To: Chair and Members of Rothesay Planning Advisory Committee
From: Brian L. White, MCIP, RPP
 Director of Planning and Development Services
Date: Monday, January 31, 2022
Subject: Rezoning - 43 Unit Apartment Building – 145 Hampton Road

An application from Mark Hatfield, Director of PropertyStar Inc. to rezone 5914m² (1.46 acres) of land (see Map 1) at 145-147 Hampton Road from Central Commercial to the Multi-Unit Residential Zone [R4] for a 43-unit / mixed used commercial apartment building subject to the terms of a development agreement.

Proposed Development Submission from Applicant

1 CONCEPTUAL SITE DEVELOPMENT PLAN
 SCALE: 1:250

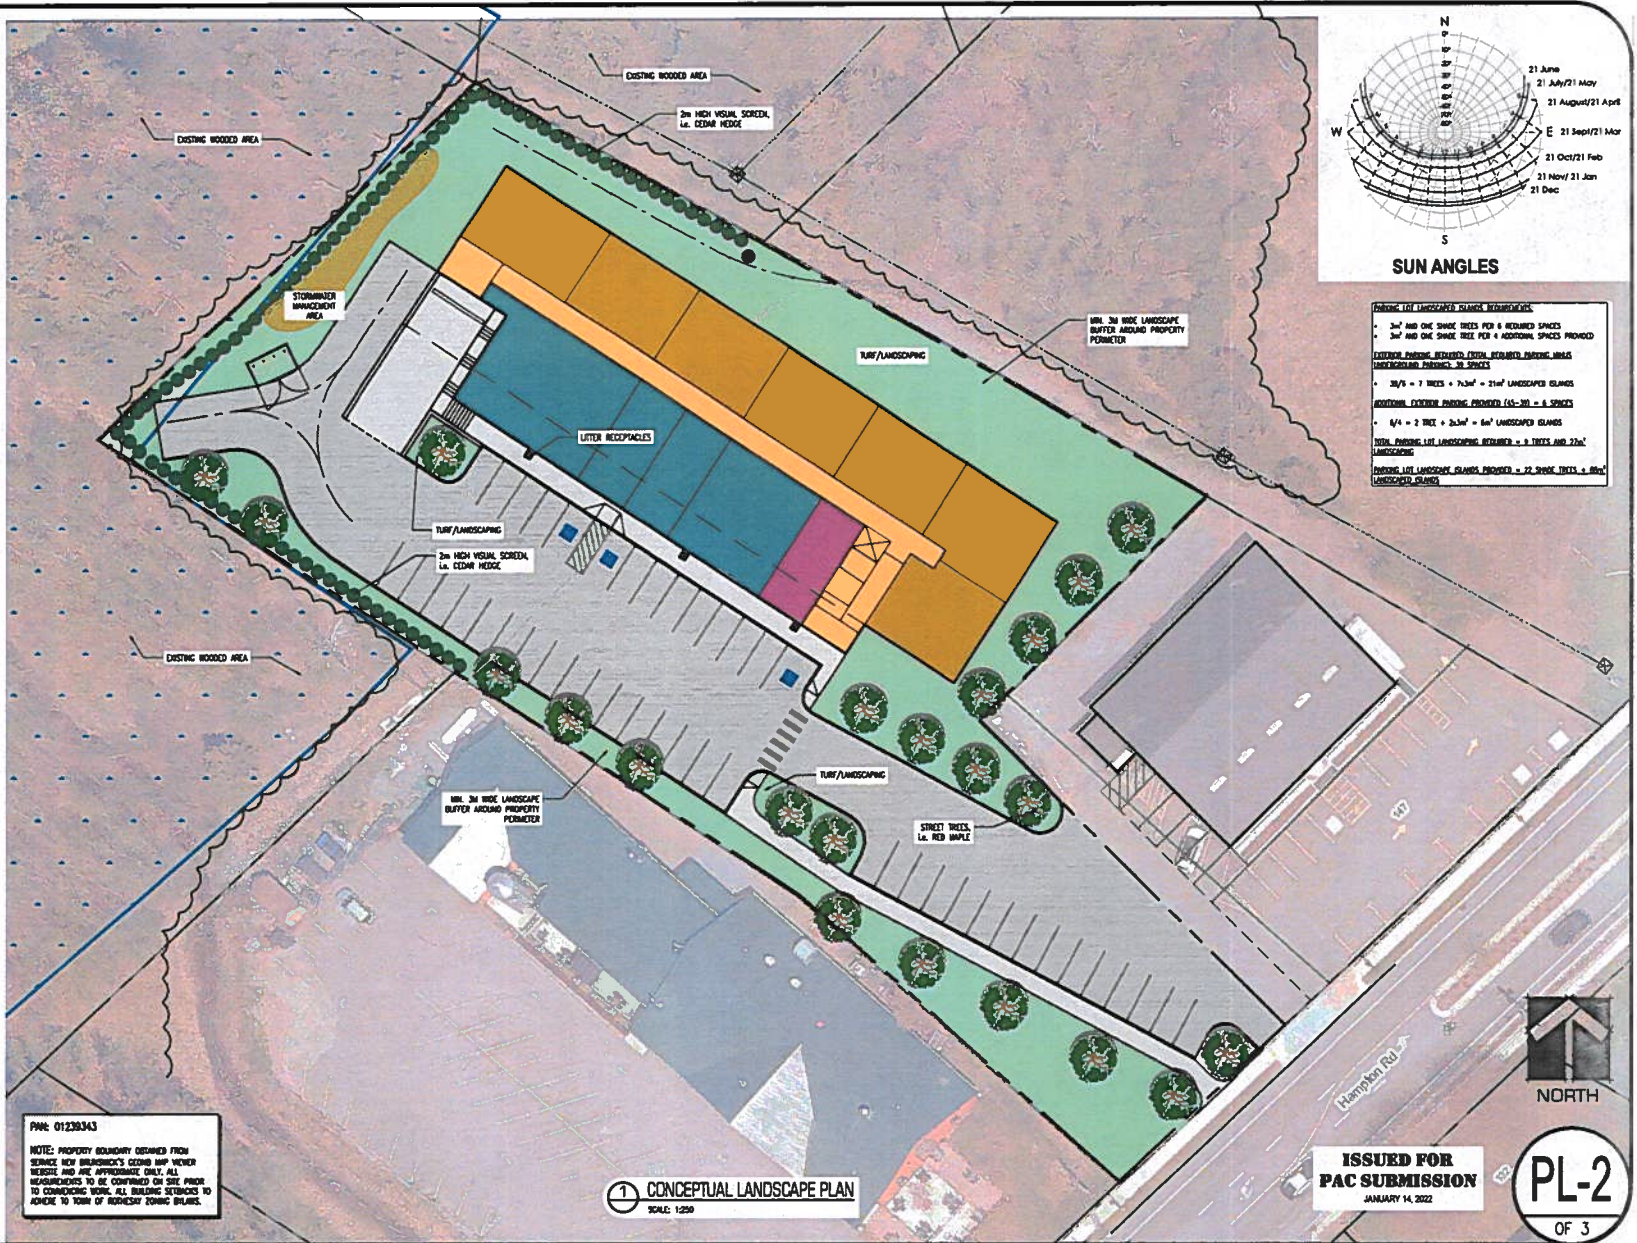
The Study Team completed a review of the proposed development access. The development site plan shows a single access on Hampton Road approximately 6m south of the existing access to 147 Hampton Road. The width of the proposed access is 6.5m. The TAC Design Guide recommends widths between 7.2 and 12.0m for commercial and multi-unit residential driveways. **It is therefore recommended that the access be widened to fit within this range.**

The centreline of the access as shown on the site plan is offset approximately 10 m north of Parkdale Avenue. This access location does not constitute good design practice as outlined in the TAC Design Guide (Chapter 8 -Access). TAC recommends that accesses on opposite sides of the road either be located directly

opposite each other or offset far enough to accommodate left turn queue space into each access. The current proposed access location is equivalent to Option A as identified in **Figure 5** below. This configuration will create conflict between northbound drivers attempting to turn left into the development and southbound drivers attempting to turn left onto Parkdale Avenue. The proposed access location and its offset to Parkdale Avenue is shown in **Figure 6**. It is recommended that the development access be shifted to the north as much as possible. Maintaining a shared access at the location of the existing access on the property would be preferred as this would reduce conflicts with left turn traffic and would make use of the existing left turn lanes.

5. Based on a review of the proposed development access, it was determined that the proposed width of 6.5m does not meet the TAC guidelines which recommended a width in the range of 7.2m and 12.0m for a two-way multi-unit residential development access. It is recommended that the access be widened to fit within this range.

6. The proposed access location will create conflicts between left turn traffic entering the development and left turn traffic entering Parkdale Avenue. It was recommended that the access be shifted as far north as possible. Maintaining a shared access at the location of the existing access on the property would be the preferred option and would reduce left turn conflicts.

1 SHADOW STUDY
 SCALE: NTS

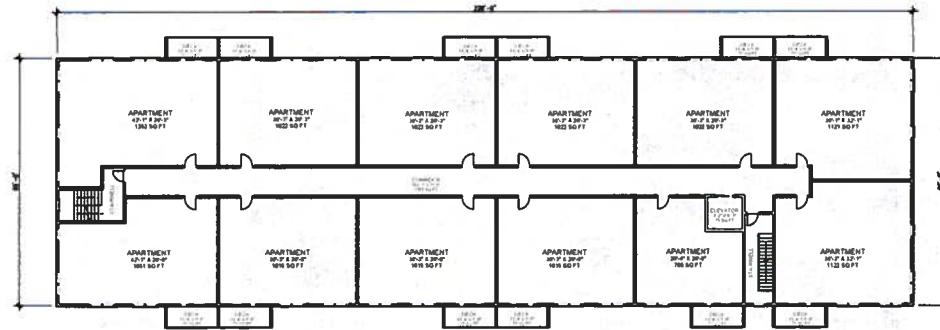
<p>Underground parking is provided;</p>	<p>The proposal includes indoor parking on the building's main level and a combination of sheltered and open surface parking.</p>
<p>Require the developer provide a technical wind and shadow study, to be completed by a certified professional, to ensure the proposed development does not generate excessive wind or cast a shadow on abutting properties or public road right-of-way that would detract from the quality, enjoyment, or use of the space.</p>	<p>The applicant has submitted a technical shadow study of the proposed building.</p>
<p>Require the developer to complete a traffic impact assessment for the proposed development on the surrounding area completed by a qualified transportation engineer or other technical specialist;</p>	<p>The applicant has submitted a traffic assessment and Staff are still reviewing the submission.</p>
<p>Excellence in site design best practices addressing features such as Crime Prevention through Environmental Design (CPTED) principles, urban design, and high quality landscaping; and</p>	<p>Staff note that because the proposed building includes ground floor commercial and it is important that the residential entrance be defined such that it is not confused with the commercial businesses and non-residents do not enter the residential portion of the building. Staff believe the residential entrance should better accentuated and well defined with landscaping, architectural design, lighting and signage.</p>
